Applicant: Florida Power Corporation

Facility: Crystal River, Unit 3

SUMMARY OF STATUS REPORT BY FLORIDA POWER CORPORATION ON THE CONCRETE SEPARATION IN THE CRYSTAL RIVER, UNIT 3 REACTOR BUILDING DOME

DOME SECTION - 90° AZIMUTH  
(GOVERNING AS IS DOME THICKNESS)

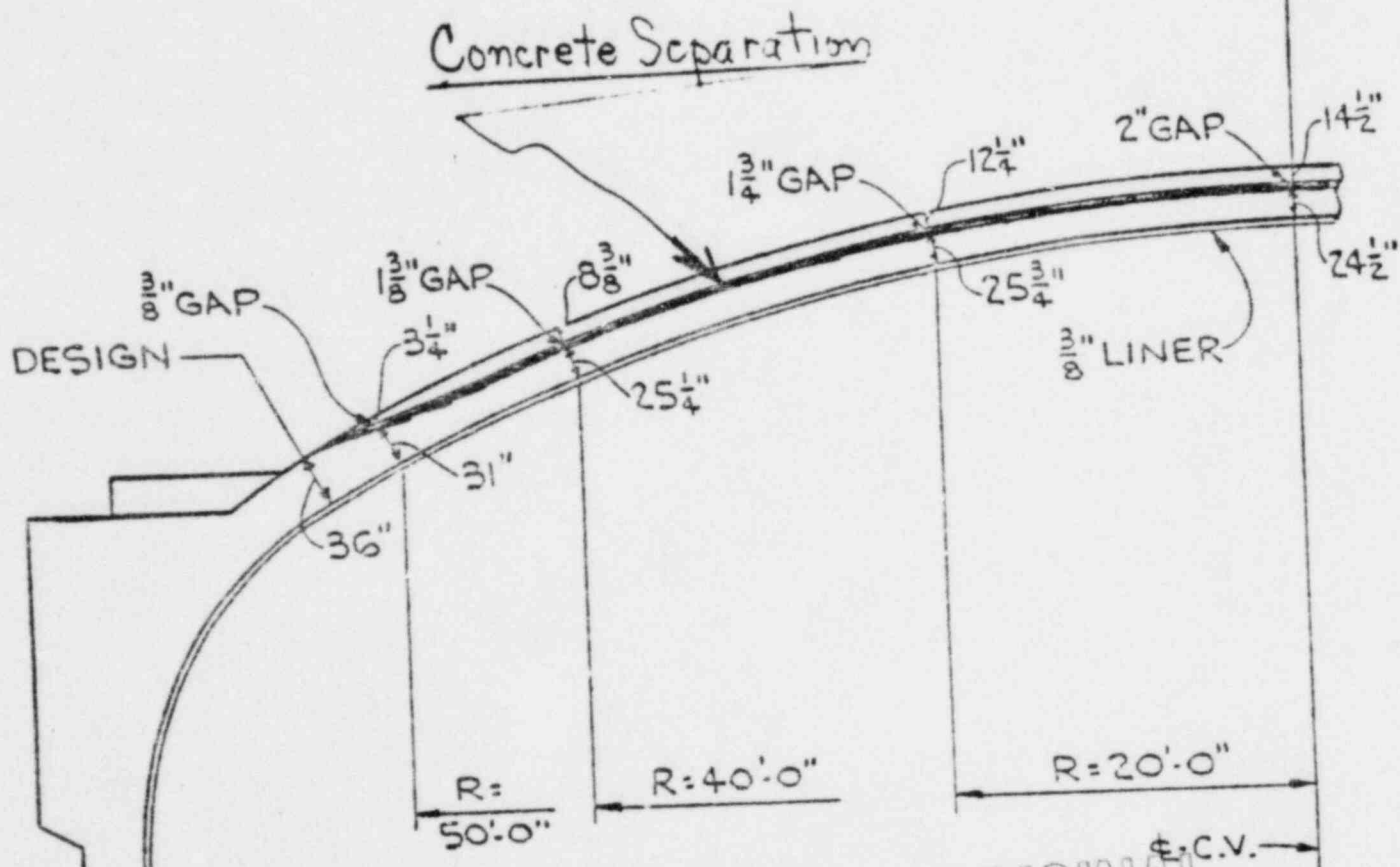
Therefore, the use of a 24" thick concrete dome section for the 2 foot analytical model does not represent the actual conditions.

- (7) Any analysis for dome models using less than the original three foot design thickness of the dome should consider the following effects:
  - (a) increase in concrete compressive stress

- (b) increase in creep as a consequence of (a)
  - (c) increase in ring girder compressive stress
  - (d) increase in the Poisson's ratio for concrete

CORE #30

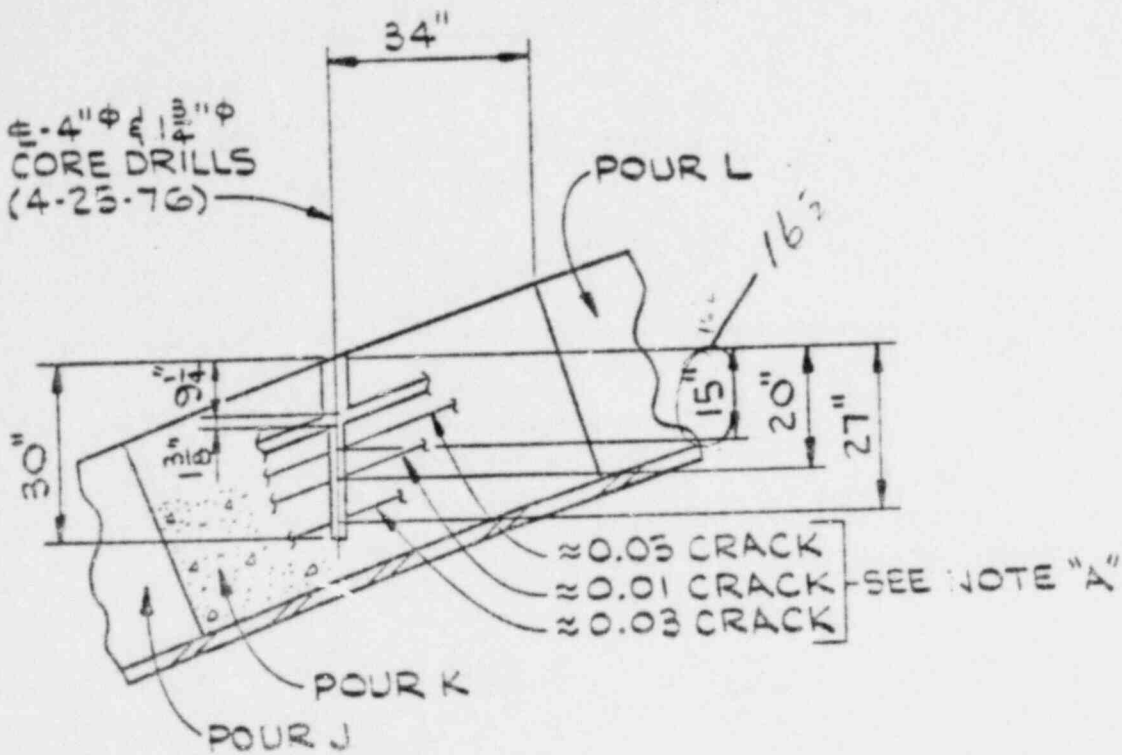
Core sample #30 has showed three cracks at the depths of 1 3/8 inches, 9 1/2 inches, and 11 1/16 inches. The core drilling program requires the use of water and it has been observed that water must be vacuumed out of the core sample holes indicating cracks are not excessive.
